ULNRC- 04558

**DOCKET NUMBER 50-483
CALLAWAY PLANT
UNION ELECTRIC COMPANY
RESPONSE TO REQUEST FOR ADDITIONAL INFORMATION
ON REVISION TO TECHNICAL SPECIFICATION 5.5.9
"STEAM GENERATOR (SG) TUBE SURVEILLANCE PROGRAM"**

**REQUEST FOR ADDITIONAL INFORMATION
REVIEW OF THE CALLAWAY PLANT APPLICATION
FOR REVISION TO TECHNICAL SPECIFICATION 3/4.4
TAC NUMBER: MB1214**

Figure R6-23. Crack A22: One and One Half Skip Reflection

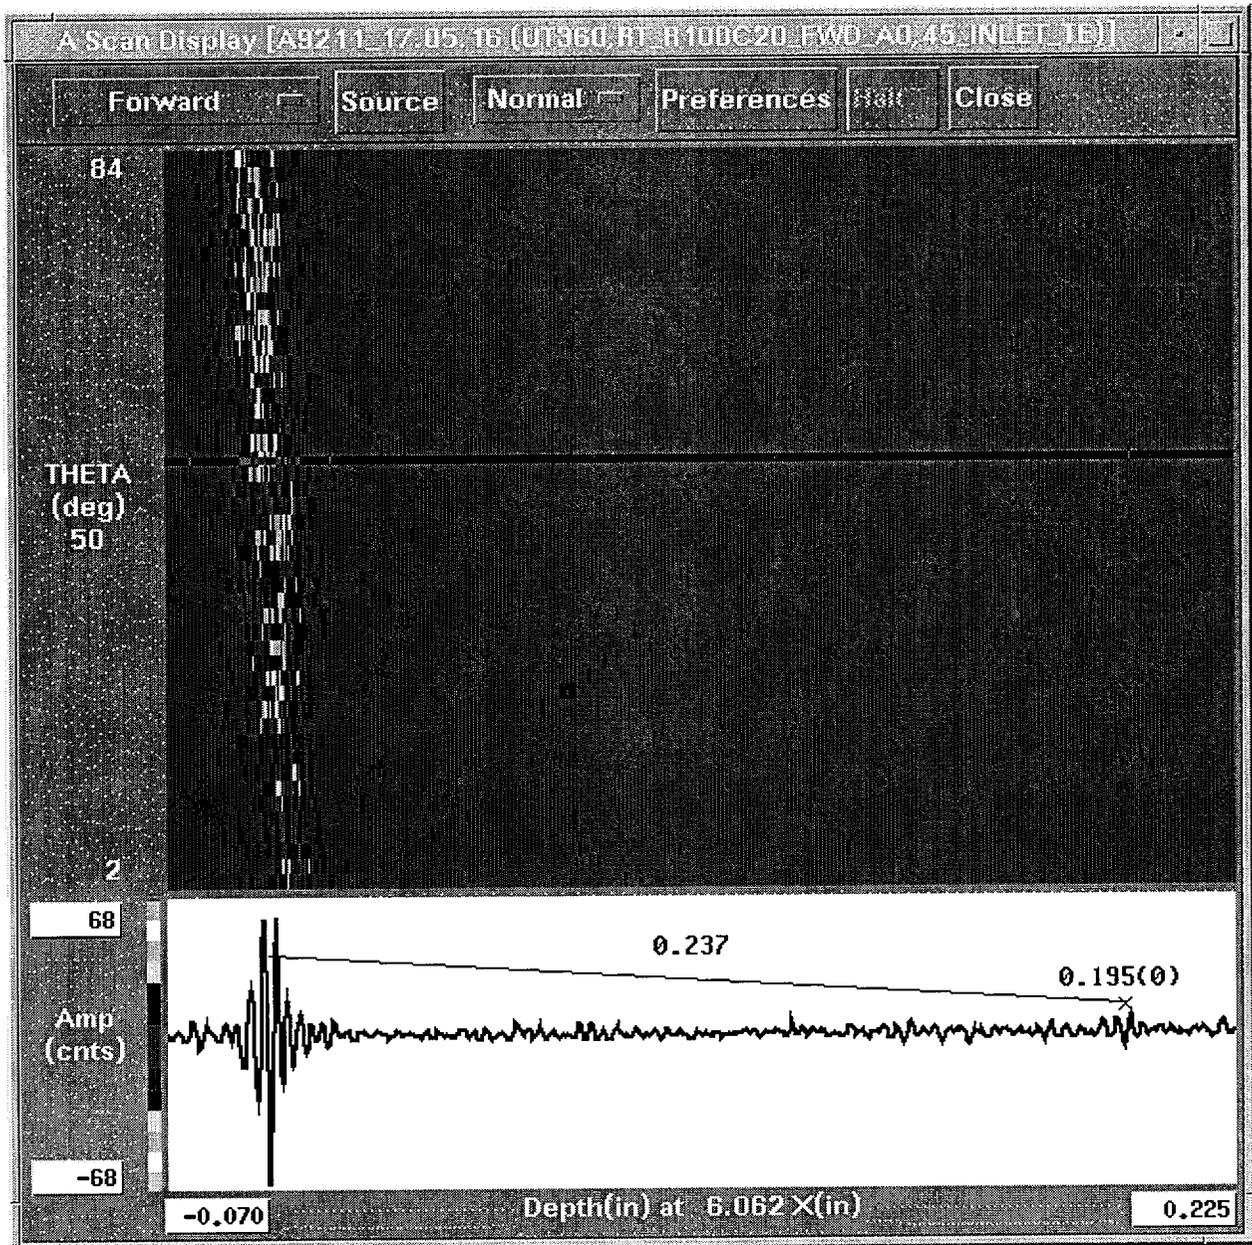
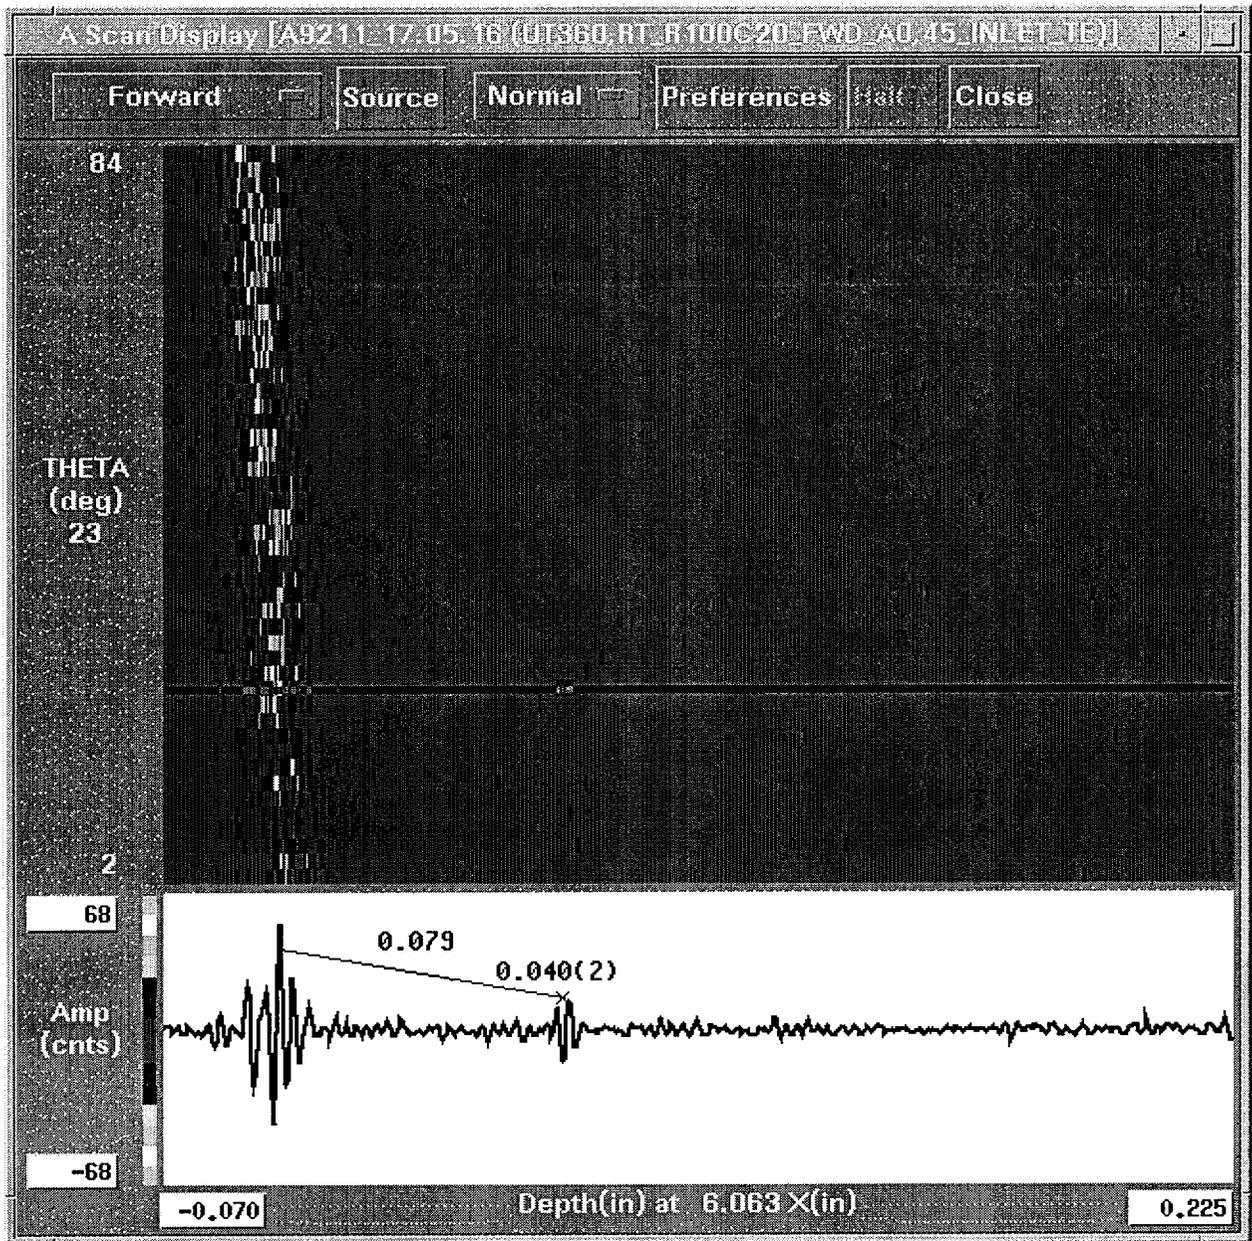
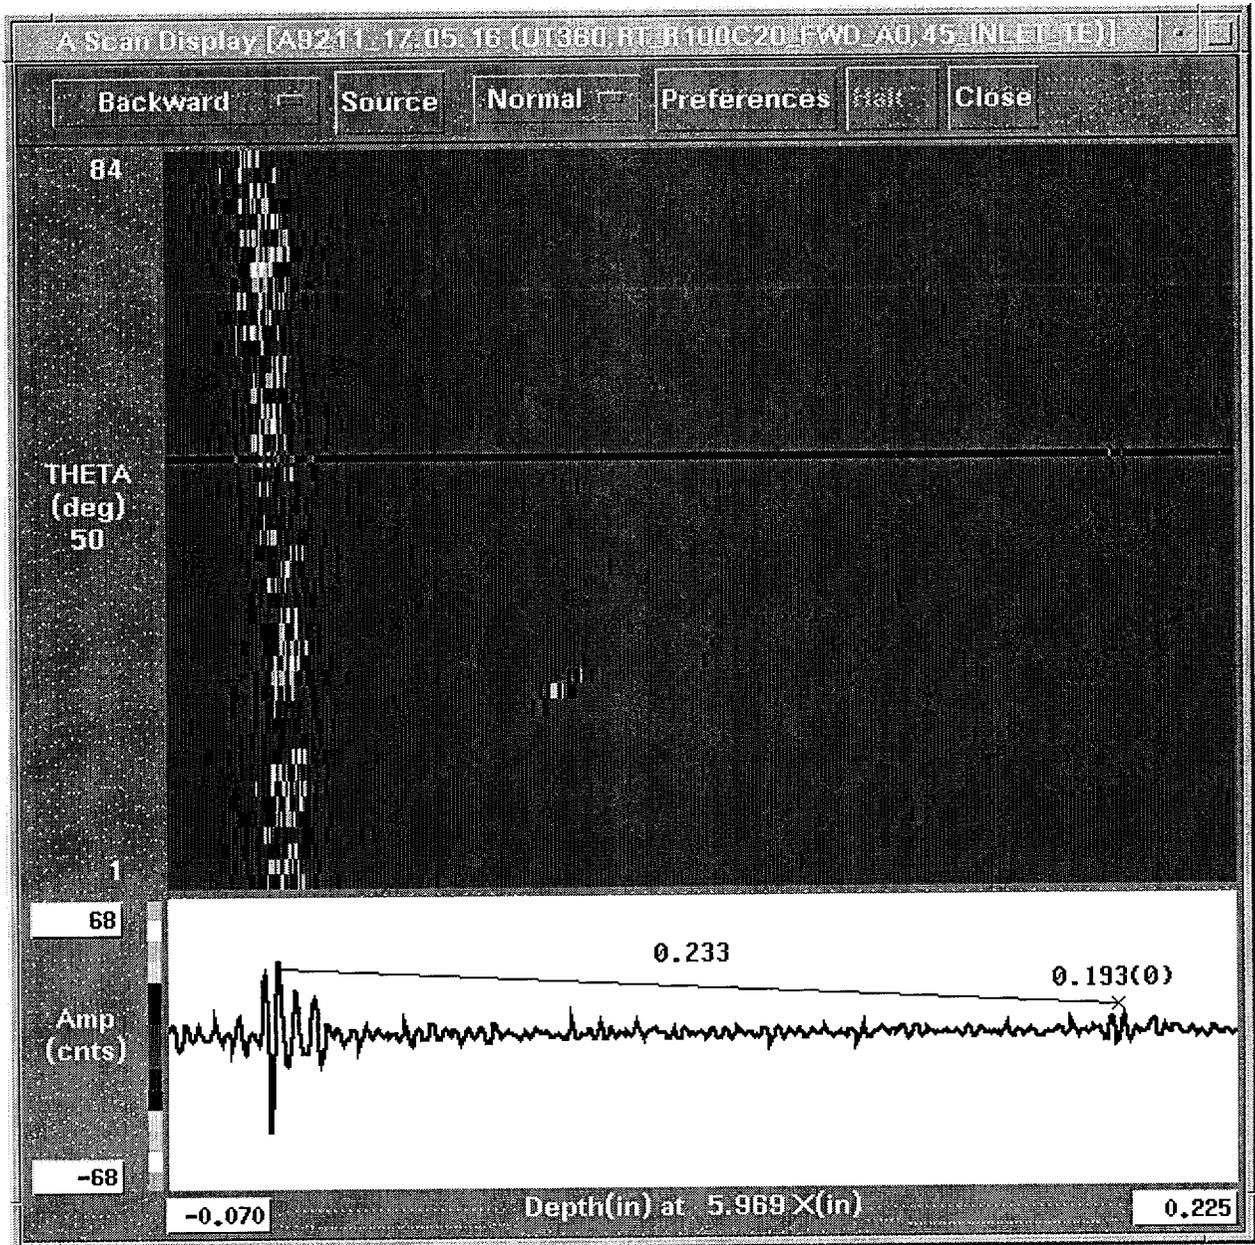
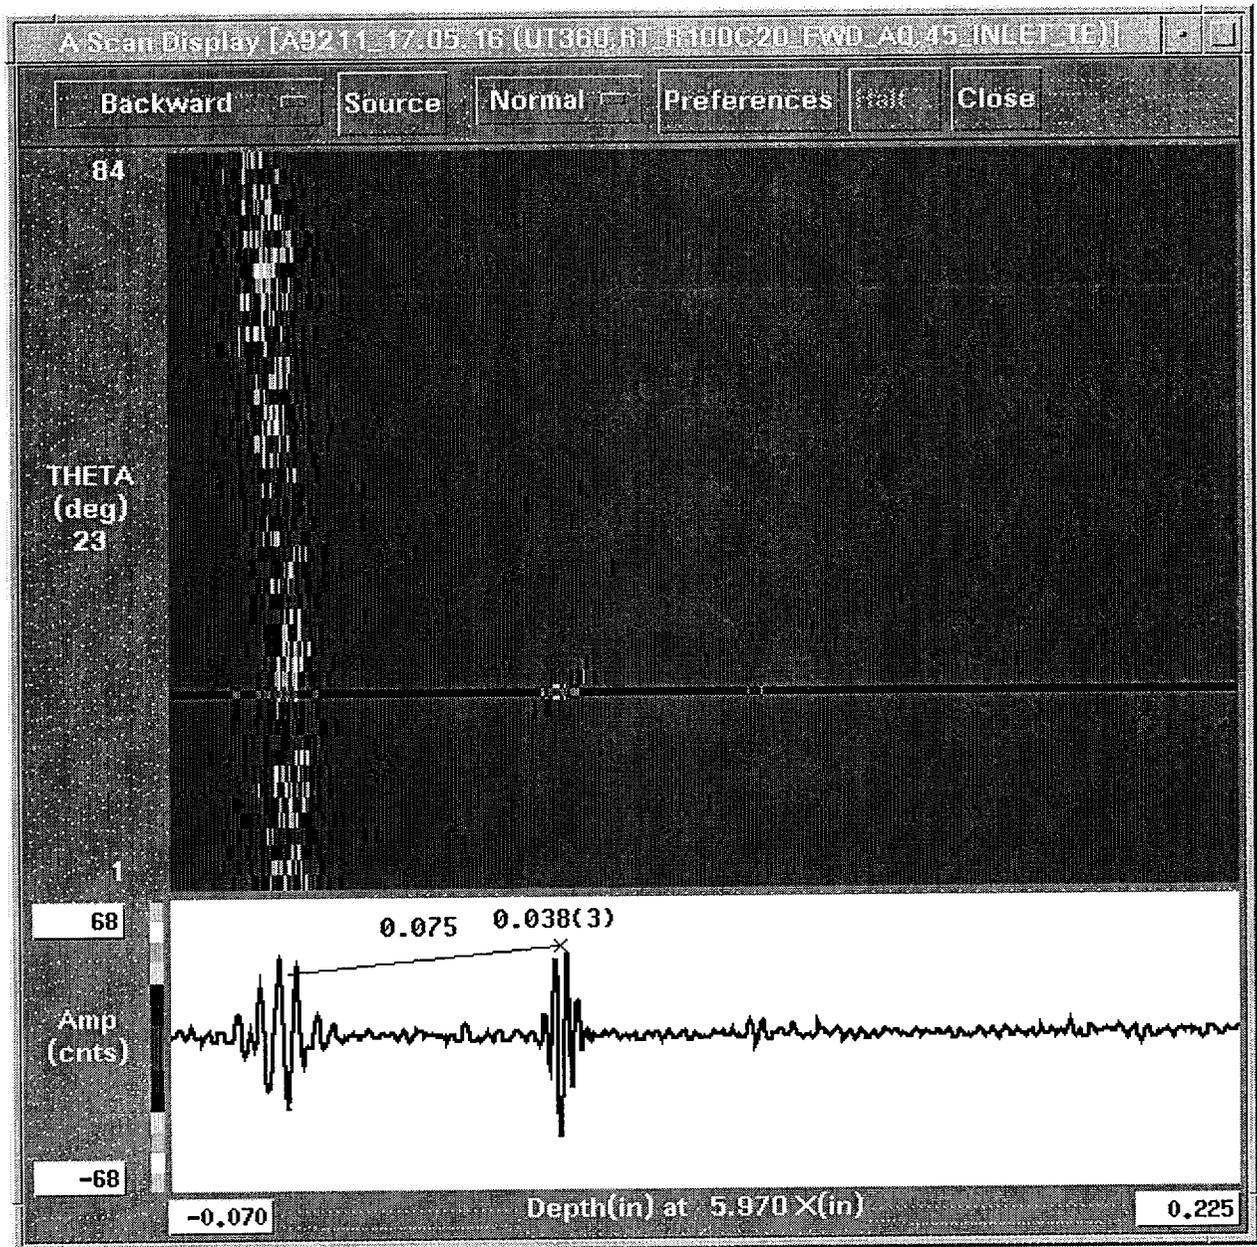
RAI # 6. During the meeting, FTI indicated that PWSCC detectability in the sleeve could be inferred from the ID notches in the UT calibration standards and the data sets containing pits. It is not clear to the staff how detecting EDM notches in the calibration standards or another degradation morphology such as pits would infer an ability to detect tight flaws such as PWSCC. Explain the basis for the statement that sleeve PWSCC ID defects will be detected, and the resulting sensitivity and POD, since the peer review (ETSS # 98404) only covers volumetric defects. Please provide additional discussion or, preferably, additional data to support the claims of the capability of the technique to detect PWSCC in the sleeve. (Question from the 6/7/01 meeting held with UE, FTI, and the NRC staff)

For crack A12, the UT measured combined wall thickness is 0.073 inch at the 6.3 and 6.4 inch axial locations. For crack A22, the UT measured combined wall thickness is 0.077 inch at the 5.9 and 6.1 inch axial locations and 0.080 inch at the 6.25 inch axial location. Both cracks are in the expansion transitions of their respective tubes. The expansion transition geometry did not adversely affect the detection of these cracks.

This is the one and one half skip reflection for crack A12 at the 6.374 inch axial location. The 0.185 inch depth (time of flight) and the 81 degree circumferential location will be used to qualify this reflection with the half skip reflection. The reflection depth from the surface, 0.225 inch, is nearly equal to the expected depth (three times the combined wall thickness) or $(0.073 * 3) = 0.219$ inch.

This is the half skip reflection for crack A12 at the 6.329 inch axial location. The delta depth is $(0.184 - 0.036) = 0.148$ inch. The delta displacement is $((81 - 56) * 0.006) = 0.150$ inch. Since these two results, (0.148 and 0.150), are within one pitch (0.015 inch), the half skip and the one and one-half skip have been correctly identified. The delta depth and delta displacement are also nearly equal to the expected value of two times the wall thickness.

This is the one and one half skip reflection for crack A22 at the 6.264 inch axial location. The 0.187 inch depth (time of flight) and the 49 degree circumferential location will be used to qualify this reflection with the half skip reflection.

This is the half skip reflection for crack A22 at the 6.266 inch axial location. The delta depth is $(0.187 - 0.035) = 0.152$ inch. The delta displacement is $((49 - 22) * 0.006) = 0.162$ inch. Since these two results, (0.152 and 0.162), are within one pitch (0.015 inch), the half skip and the one and one-half skip have been correctly identified. The delta depth and delta displacement are also nearly equal to the expected value of two times the wall thickness.
